Addendum No. 1

May 22, 2025

**City Project No.: 23-067, Package 3
Roads Program Capital Improvement Project**

DETAIL B: SHALLOW UTILITY TRENCH SECTION (TOP OF UTILITY IS 6" TO 24" BELOW THE PAVEMENT SECTION)
SCALE: NTS

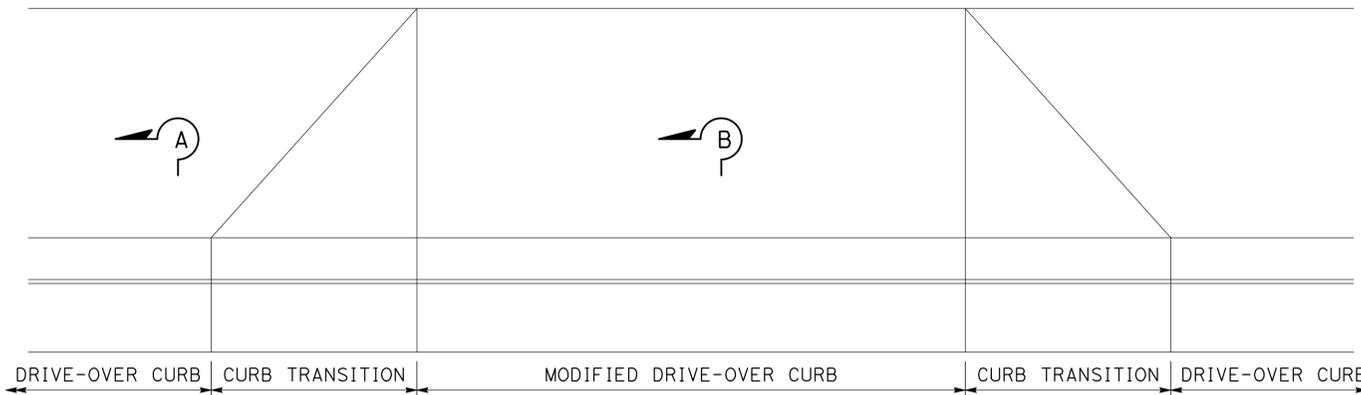
Revisions consist of various items that clarify callouts, handling of shallow utilities, Christine Way and Heppner Way roadway and concrete reconstruction limits and grading, mid-block curb ramp near Arbor Way and Heppner Way, crosswalk removal, fence removal along Wallace St, crossing utilities with the proposed drainage system, and construction funding sign detail.

A: Based on this question, the shallow utility strategy has been revised. Bid items have been added for Excavate and Expose Utility (LF) and Cement Slurry (2-sack) (LF). Please refer to the modifications in the plans and the specifications.
